# Mapleton City Planning Commission Staff Report

Consideration of Final Plat approval for the Harvest Park Plat "G" subdivision consisting of forty (40) lots located in the Specific Development Plan (SDP-1) zone (approximately 1750 W Elm).

## MAPLETON CITY DEVELOPMENT REVIEW COMMITTEE MINUTES

On March 12, 2013 Jerry Robinson submitted revised plans for Harvest Park Plat "G", a 40 lot subdivision located generally at 675 S 1750 W.

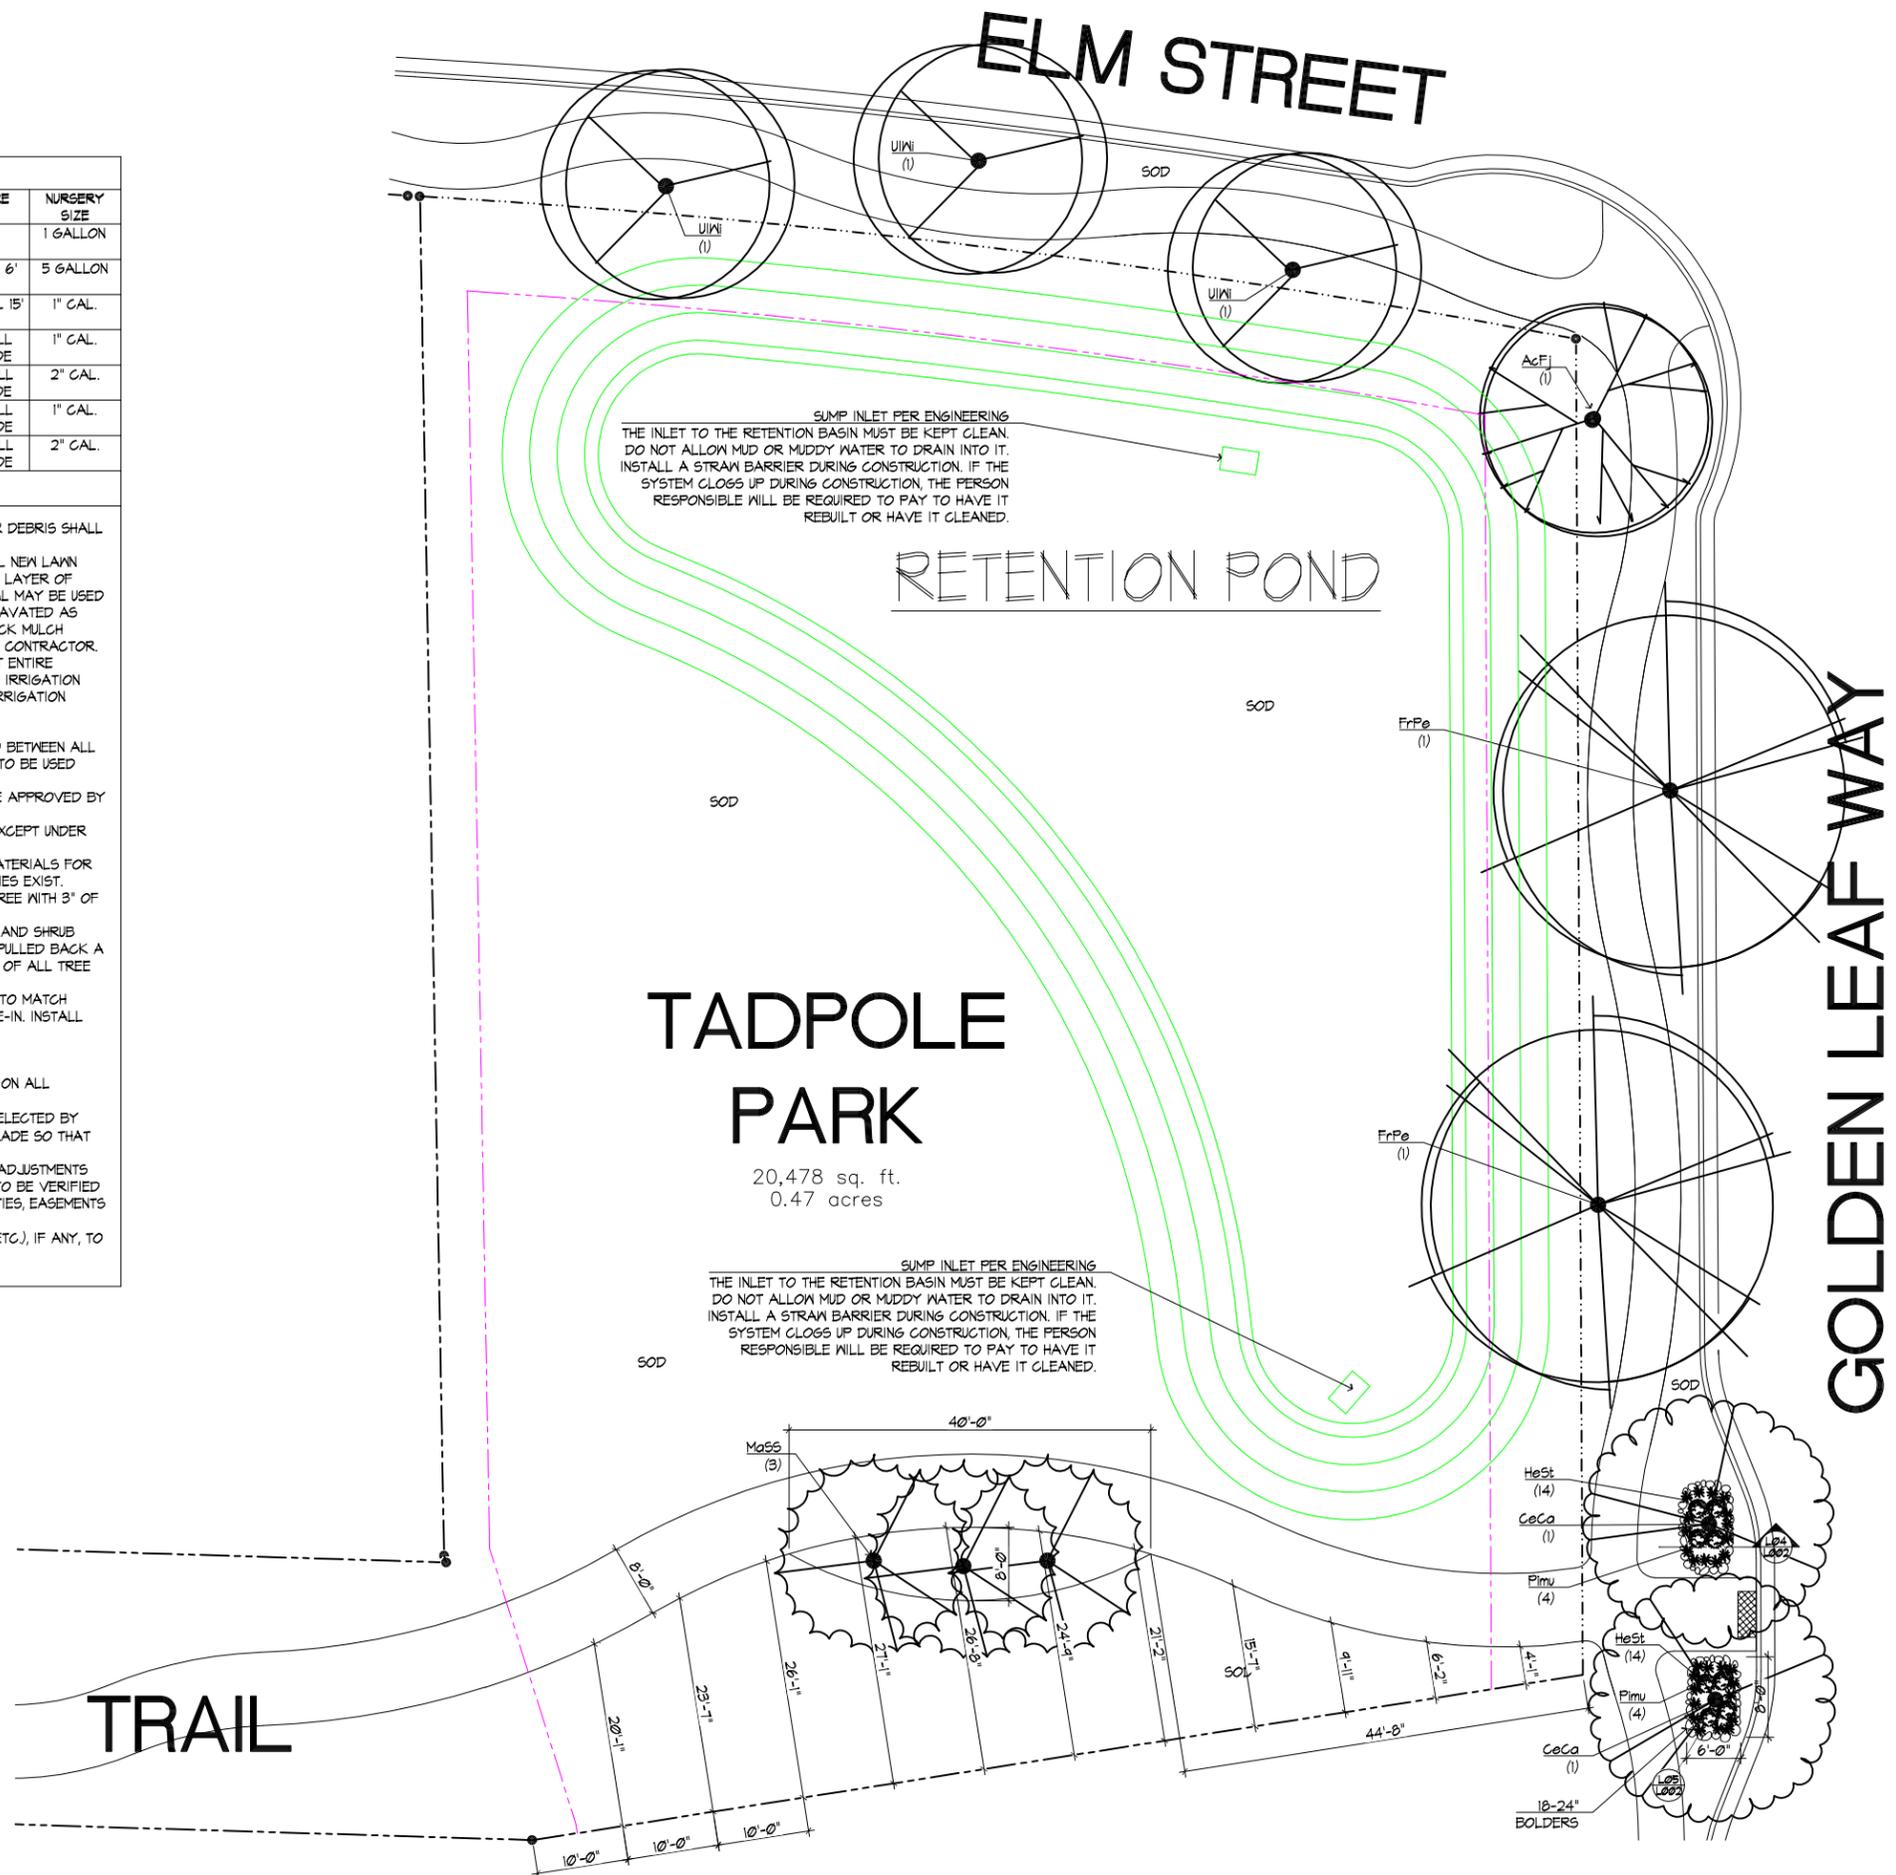
1. Clearing and Grubbing, assure that the existing concrete debris on site is not place in the R/W.
2. Remove all existing concrete sidewalk, curb and gutter that does not meet current city standards.

1. Fire Hydrant 500' spacing minimum, show existing FH to assure correct spacing.
2. Water model to be reviewed by RB&G at developer's expense. This will need to be submitted to the city.

1. Geo-tech report will need to be revised and resubmitted, this report will address why the storm drain basin was decreased in capacity from 16,385 c.f. to 10,681 c.f.
2. Design storm drains for 100 year storm.
3. The storm drain basin at Elm and 1750 West will need a landscape plan submitted.
4. City code requires "The owner of property to be served by an onsite storm water management facility must execute an inspection and maintenance agreement. (21.04.040 Storm water Design and Management Standards).

- a. This agreement is required for all storm water management sites that are not owned by the city.
5. SWPPP and Land disturbance permit required.
  - a. Adjust SWPPP to access off of Slant Road as per HOA requirements.
